Subject: Submission #7: Buckle & Dorsen. 41-43 Beach Road Collaroy NSW 2097 DA
2019/1522

SUBMISSION: BUCKLE & DORSEN
a written submission by way of **further** objection to DA 2019/1522

Re: 41-43 Beach Road Collaroy NSW 2097
DA 2019/1522

WRITTEN SUBMISSION: LETTER OF OBJECTION
Submission #7: Buckle & Dorsen

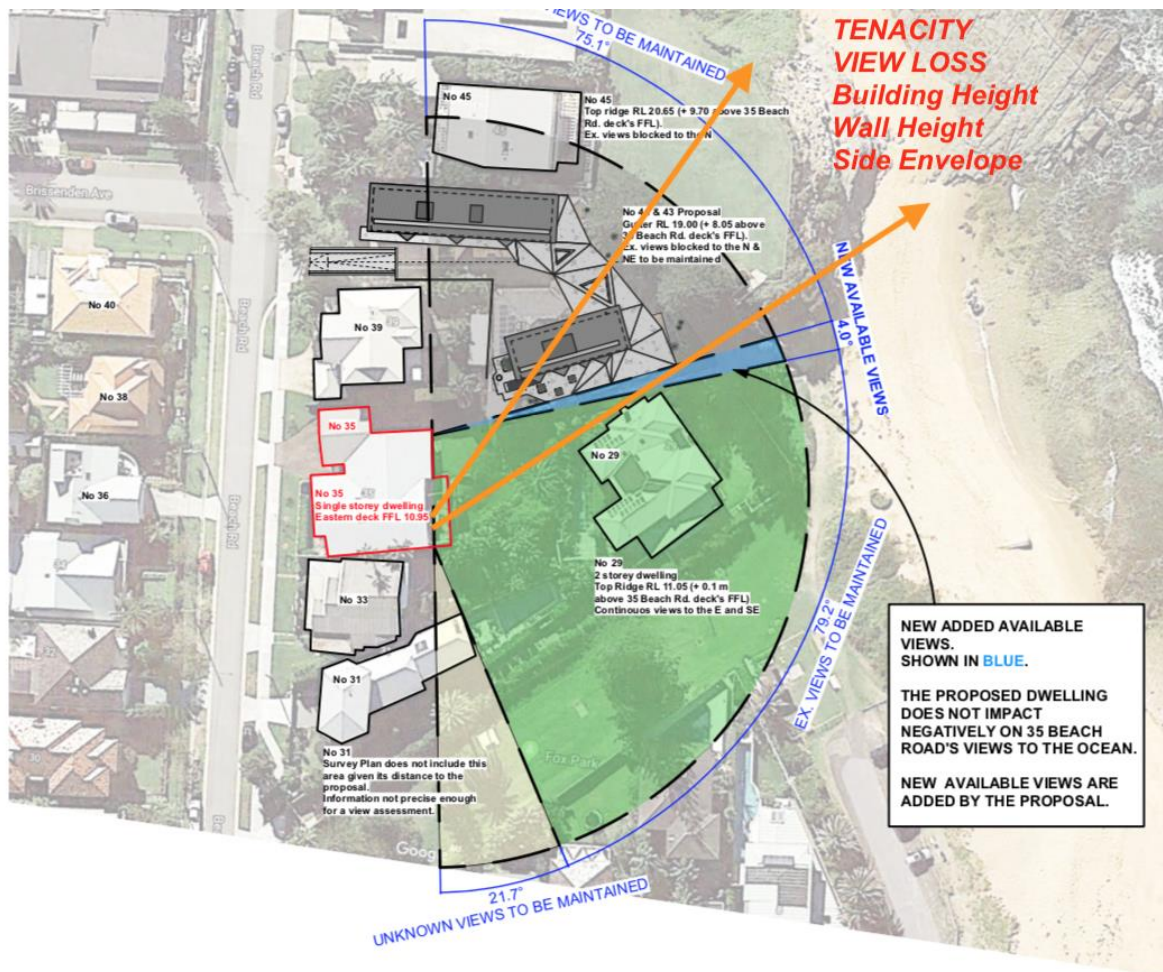
The Applicant has failed to provide a Tenacity Assessment on View Loss from 35 Beach Road Collaroy.

The 'Tenacity' headland view and water view from future upper level is from the Living Room and Deck, the loss is a moderate loss, and the non-compliant development to height controls causes that loss. The loss of the headland view is unacceptable as it provides a natural frame to the view that exists for 35 Beach Road Collaroy, and for many elevated houses to the south that share this view.

We also note that the applicant has not carried out a *Tenacity Assessment*. We present such an assessment.

The applicant has failed to even correctly identify the location of the Living Rooms on their very limited plan consideration.

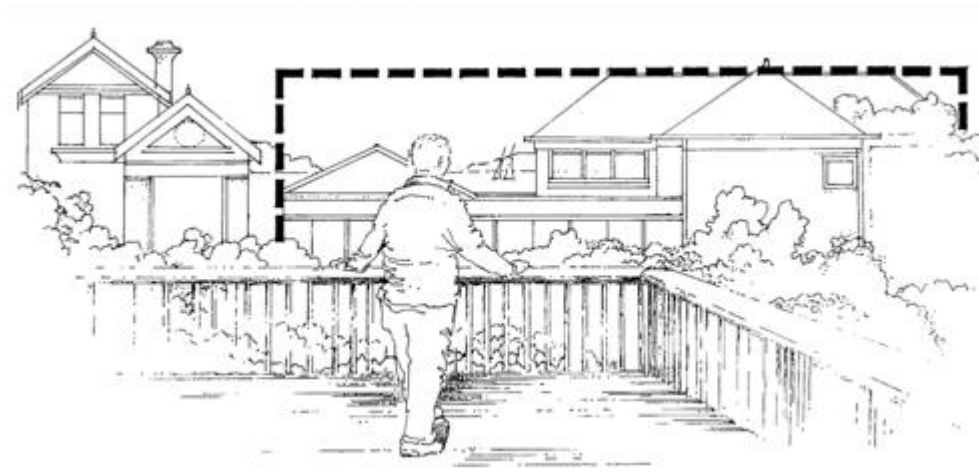
As the proposed development does not comply with outcomes and controls, that are the most relevant to visual impacts, greater weight would be attributed to the effects caused.

In my opinion the extent of view loss considered to be greater than moderate, in relation to the views from my living rooms and living room deck of my dwelling, particularly to the north and east towards the water view.

The view is from a location from which it would be reasonable to expect that the existing view, could be retained especially in the context of a development that does not comply with outcomes and controls.

Where there is a potential view loss, Council should require a maximum building height of less than 8m for part of the building, and should consider other modifications to the design to achieve view sharing.
